SITING AND GRADING PLAN

Royal Pine Homes / Centerfield Properties Inc - 216102
"OAKRIDGE MEADOWS", RICHMOND HILL, ON

BLOCK 52

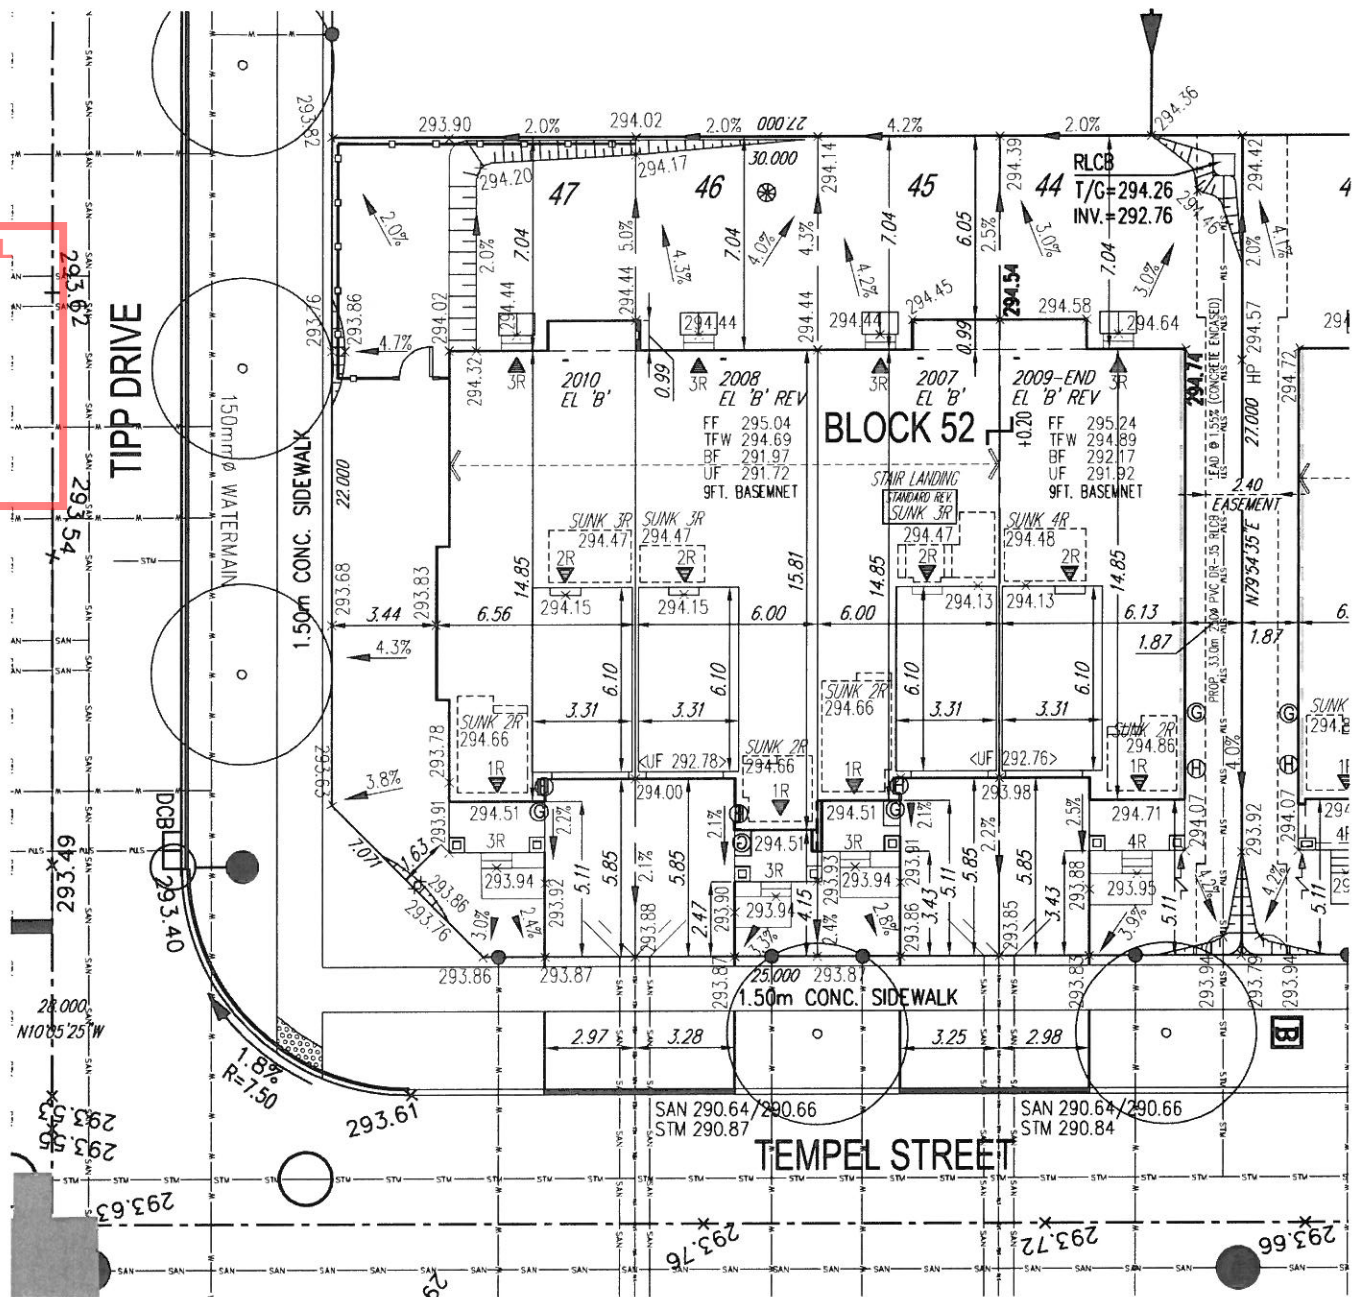
No unprotected openings permitted within 1.2 meters of the lot line as per article 9.10.14 of the Ontario Building Code.

As per OBC 2012, Div.B, 9.10.14.5(5), projections such as balconies, eaves, stairs, etc., that are more than 1m above grade, shall be non-combustible when within 1.2m of a property line or 2.4m of a combustible projection on another building on the same property.
